U.S. NUCLEAR REGULATORY COMMISSION
REGION I

Report No. 50-317/84-18
50-318/84-18

Facility Name: Calvert Cliffs Nuclear Power Plant, Units 1 & 2

June 12 - July 10, 1984: Inspection Report 50-317/84-18, 50-318/84-18

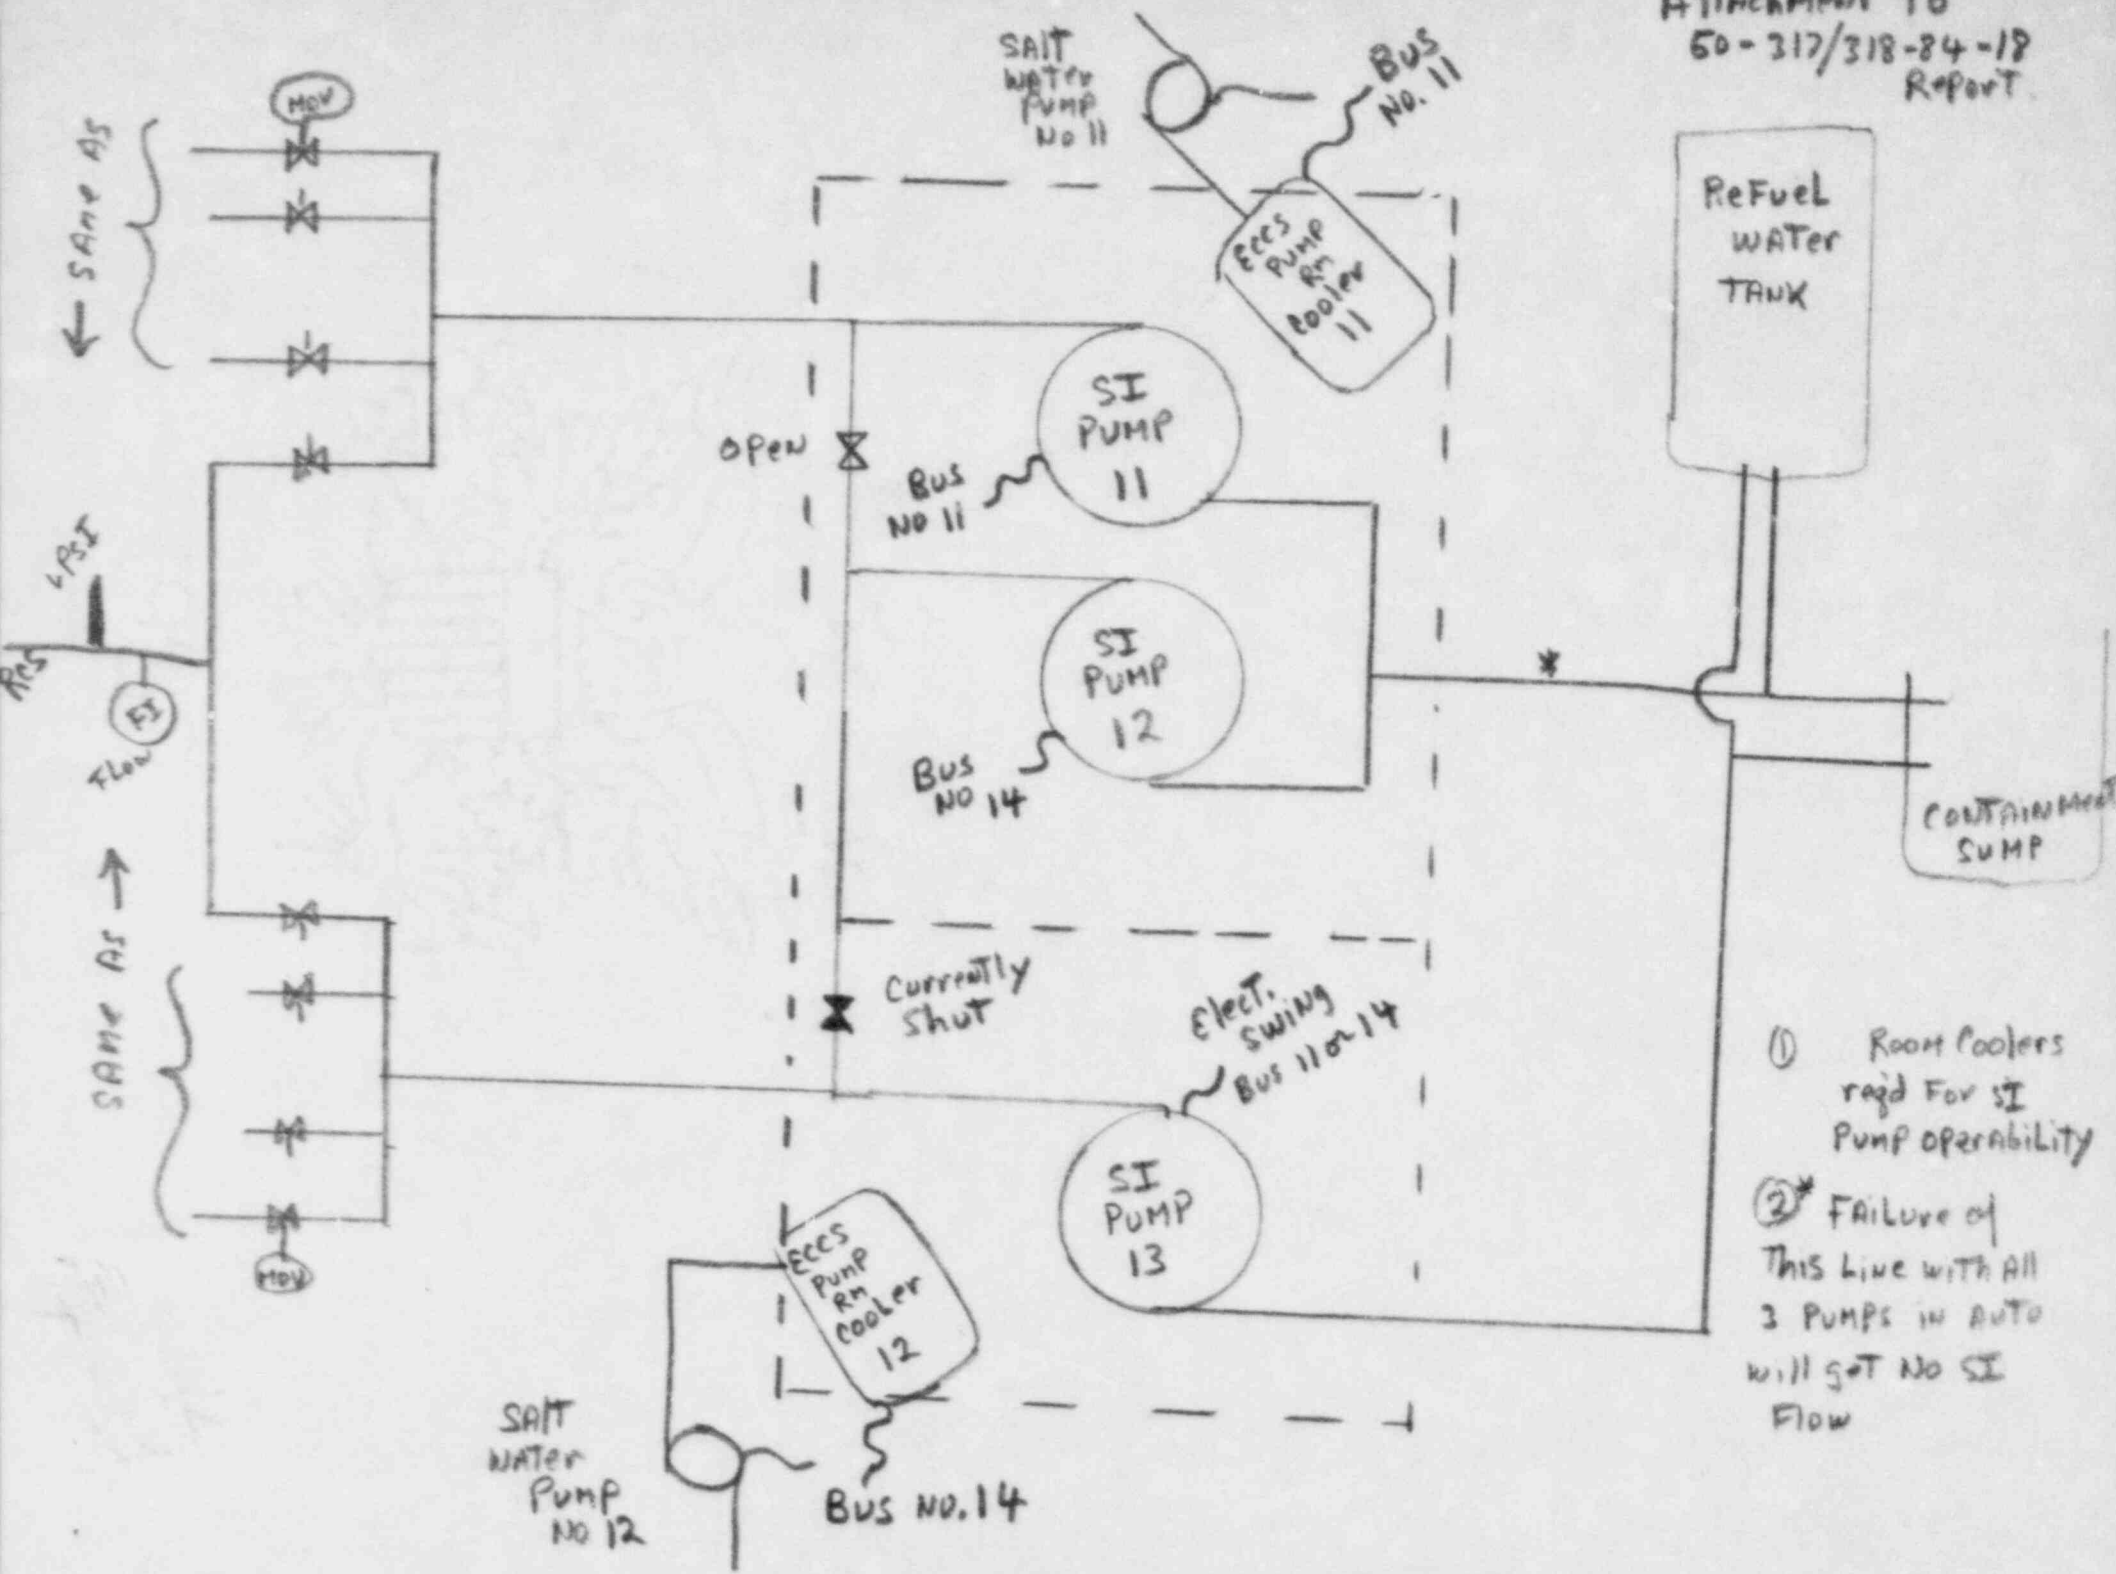
- On June 15, 1984, the inspector observed in the June 14 shift night orders that number 22/12 Safety Injection (SI) pump was to be placed in the "Pull to Lock" position and that valve (1 and 2)-MOV 653 was to be shut. These instructions significantly deviated from past practices and disable from automatic operation one of the SI pumps for each unit.

Further investigation of this revealed that the licensee had postulated a particular scenario where a Loss of Coolant Accident (LOCA) occurred simultaneous with a loss of offsite power and failure of one diesel generator. The postulated scenario with the previous operation conditions (one SI pump electrically powered from one vital bus and the other two SI pumps connected to the other vital bus) would result in a failure of the vital bus that powers the two SI pumps connected to it, and leave just one SI pump to mitigate the accident. The licensee also postulated that with just one SI pump operating under full flow conditions the single pump would have a high probability of "running out" causing cavitation and possible loss of suction if both piping headers were cross connected as in past practice (closing MOV-653 separates the headers). The licensee further explained that because of the physical arrangements, the design of suction piping and electrical configuration and logic, that separating the discharge headers and placing one HPSI pump in pull to lock provided more reliability and assurance that two separate redundant trains of emergency actuating features would be available in the event of an accident (see drawing attached at end of Report).

The placing of the number 12 and 22 HPSI pump handswitches in the "pull-to-lock" position changes the HPSI pump starting logic as described in the FSAR.

10 CFR 50.59 requires that the licensee make a determination that an unreviewed safety question does not exist for changes made to the facility as described in the FSAR and that a written safety evaluation be recorded which provides the basis for the determination. Such a written safety evaluation was not provided for the HPSI handswitch position changes. This is a violation. (317/84-18-01)

- ① Room Coolers req'd For SI Pump operability
- ② Failure of This Line with All 3 Pumps in AUTO will get NO SI Flow
